Project Name: Webster University Interdisciplinary Science Building **Project #:** 945

SUBJECT: Submittal 945-04, Rev #0 Brick shapes

RE: Clay Faced Brick Special Shapes Shop Drawing

Full Range Select - Modular
Webster Univ. Brick Shape
Scale: 3/4" = 1", Solid 2 1/4"
Date: 6/17/16
Geoff Dunlap

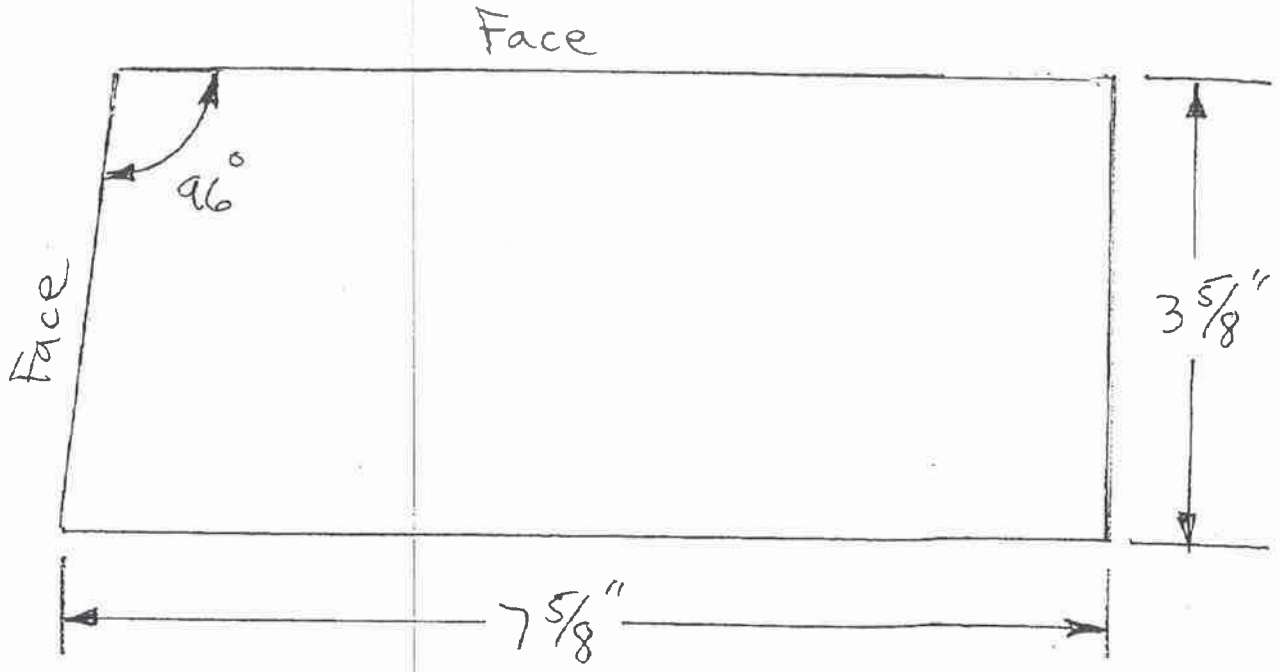
Rejected - Submit special corner brick per drawing 8/A0457
